**ITEM 7. SECTION 96 APPLICATION: 485-521 HARRIS STREET ULTIMO****FILE NO: D/2014/1147/A****SECTION 96 APPLICATION NO: D/2014/1147/A****SUMMARY****Date of Submission:** 24 March 2016, amended 31 October 2016**Applicant:** Mr Giovanni Cirillo**Architect:** Architectus**Developer:** TWT Property Group**Owner:** Timkit Pty Ltd**Cost of Works:** \$98,739,301**Proposal Summary:** Section 96(AA) modification application to amend Stage 1 building envelopes for a mixed use development. Proposed changes include modifications to the configuration of the approved building envelope.

This Section 96 application is the result of a Stage 2 detailed design proposing to vary the building envelopes approved under a Stage 1 development consent (D/2014/1147) granted by the NSW Land and Environment Court and a subsequent design competition. Consequently, the Section 96 modification and Stage 2 development application are being assessed concurrently. Both reports are before the CSPC for review and determination.

**Figure 41:** View from the sun at midwinter, with the Stage 2 envelope depicting the rear open space at 32 William Henry Street (red arrow) in shadow at 11.00am.

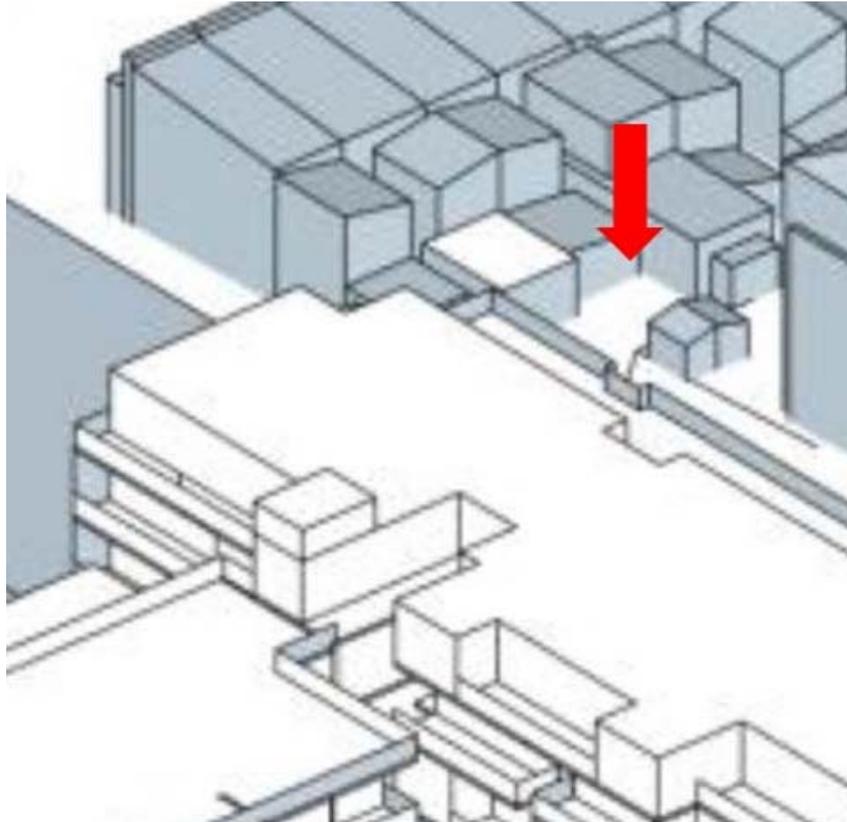
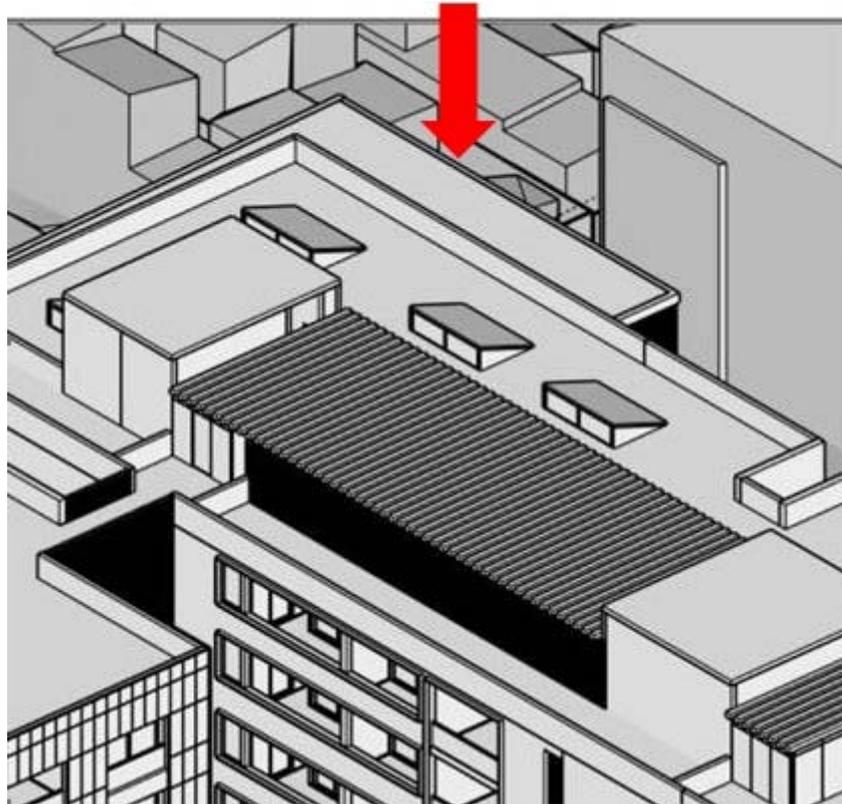
54. The additional massing proposed to Levels 5 and 6 to the Bulwara Road frontage of the site at its south-western corner creates overshadowing to the rear private open space of the terrace house at 32 William Henry Street, Ultimo (as depicted in the views from the sun in **Figure 40 and 41** below). This additional overshadowing reduces solar access to this private open space to less than 2 hours at the midwinter solstice.
55. The overshadowing from the additional massing does not comply with the relevant solar access provisions of the ADG or the Sydney DCP 2012. The proposed amendment to the building envelope is not supported as a result.

- (b) In the event of any inconsistency between the approved plans and supplementary documentation, the plans will prevail.
- (c) ***No approval is granted for a nil setback to Bulwara Road at levels 5 and 6. A four metre setback must be provided for the full length of Bulwara Road at levels 5 and 6.***

- (c) is inconsistent with the existing low to medium scale streetscape character of Bulwara Road.
52. Condition (2) of the Stage 1 development consent has therefore been recommended to be modified so as to not grant consent to the additional massing in this location.
